**MEMORANDUM No. US-CA-SLO-TM-001-0 Rev. 0**

To: Dr. Blaine Reely  
Company, San Luis Obispo County, Groundwater Sustainability Director  
Position:  
Subject: Los Osos Basin Groundwater Flow and Seawater Intrusion Model  
CC: NA  
From: Jim McCord, PhD, PE, IRP Water LLC  
Randall T. Hanson, One-Water Hydrologic LLC  
Date: 19 September 2025

**Figure 1. Presentation of Observed and Simulated 250 mg/L contour**

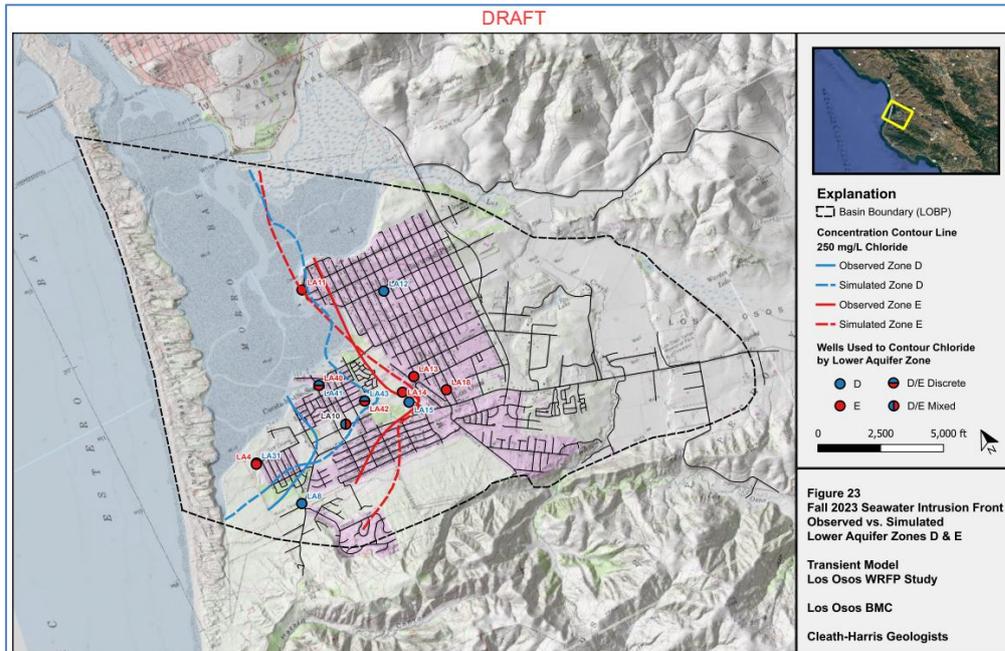
Even with the rather detailed data available for the Los Osos basin, it is difficult to accurately define current location of the 250 mg/L contour. This is illustrated by Figure 23 from CHG (2025), reproduced here as **Fig. 1**. In this figure, it is impossible to accurately draw the 250 mg/l contour. This is because

the 250 mg/l “Observed” contour shown in the figure represents some kind of interpolation based on sparse data, and it should be considered to have a wide band of uncertainty about it. This uncertainty in the observational data results in difficulty in assessing the model skill at simulating its current location and rate of movement in each of the aquifer layers. Plotting an uncertainty envelope about the simulated 250 mg/l from model sensitivity analysis combined with plotting the observed contour uncertainty envelope would help convey the current knowledge conveyed by the available data.

CHG (2025a) did perform a limited sensitivity analysis with the model, but not with flow and transport parameters linked. A graphical presentation of the predicted 250 mg/l contour from a sensitivity analysis could help visually convey the uncertainty in the modeled location compared to the uncertain observed 250 mg/l envelope, and that would provide a more objective way of assessing model skill (or how accurately the model is reproducing observations).

In short, the current model prediction of the 250 mg/l cannot be considered objectively accurate without further analysis of the existing data and model sensitivity results, and only the collection of additional data can help constrain the predictive uncertainty of the model. Some of this uncertainty analysis and related data collection can be part of future or proposed work and will be part of future analysis and refinements of the model and interpretation of model results.
